SUBJECT: ADDENDUM No. 1

FILE: FHWTP Flocculation and Sedimentation Basins 1 & 8 Equipment Upgrade WT7093

**FLEMING HILL WATER TREATMENT PLANT FLOCCULATION AND
 SEDIMENTATION BASINS 1 & 8 EQUIPMENT UPGRADE PROJECT – WT7093**

9
NEW 1 1/2\"/>

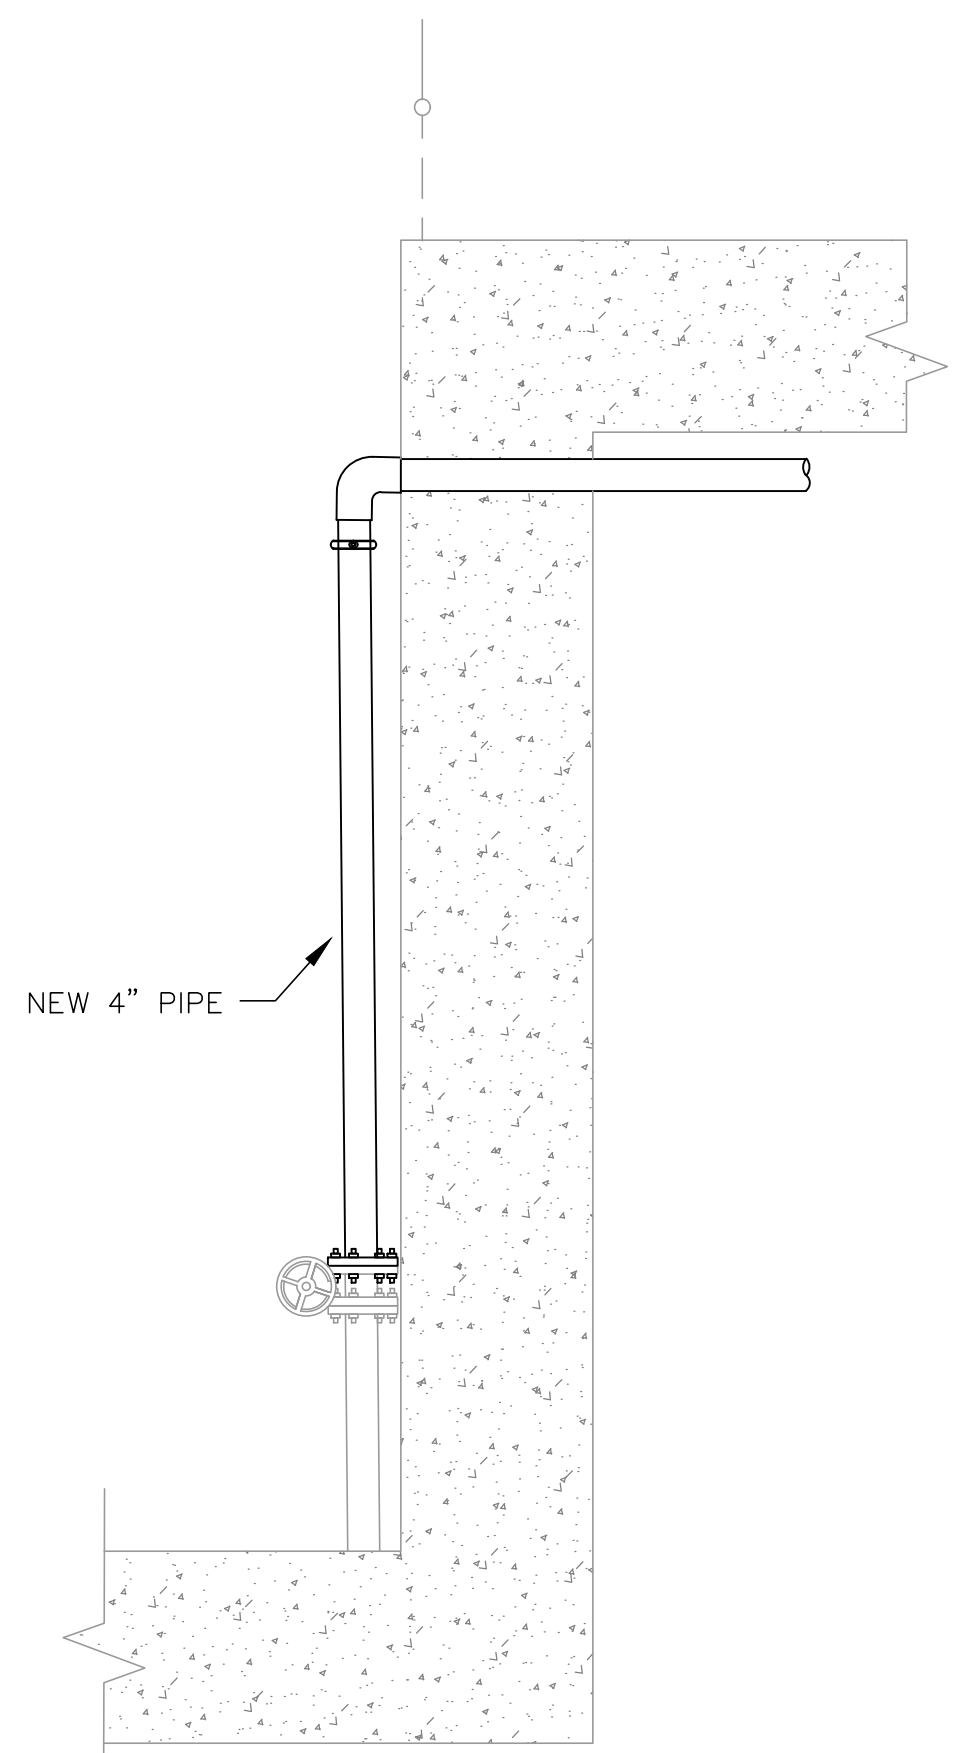
Sheets 21: Added notes. Combined and modified Details 5 and 6.

14) Question: Sheet 21. We are to provide new spray nozzles, blow off assembly, and wye strainers, but have not found a specification for anything other than the ball valves. In addition, it is not clear what the layout (spacing) or quantities will be required.

Response: Spray nozzles shall be 1/4" with a 128 degree spray angle (flat spray) at 20psig or equal. Five (5) sprayers will be required per spray piping run for a total of thirty five (35) sprayers (Basin 1 only).

Wye Strainers shall match pipe size, stainless steel 316 with 1/32-inch perforation per spray piping run (Basin 1 only).

Blow off assemblies at the end of spray piping runs shall be as follows:

Ball Valve with a 90 degree bend per spray piping run for sedimentation basin (Basin 1 only).

Ball Valve with two 90 degree bends per spray piping run for flocculation basin (Basin 1 only).
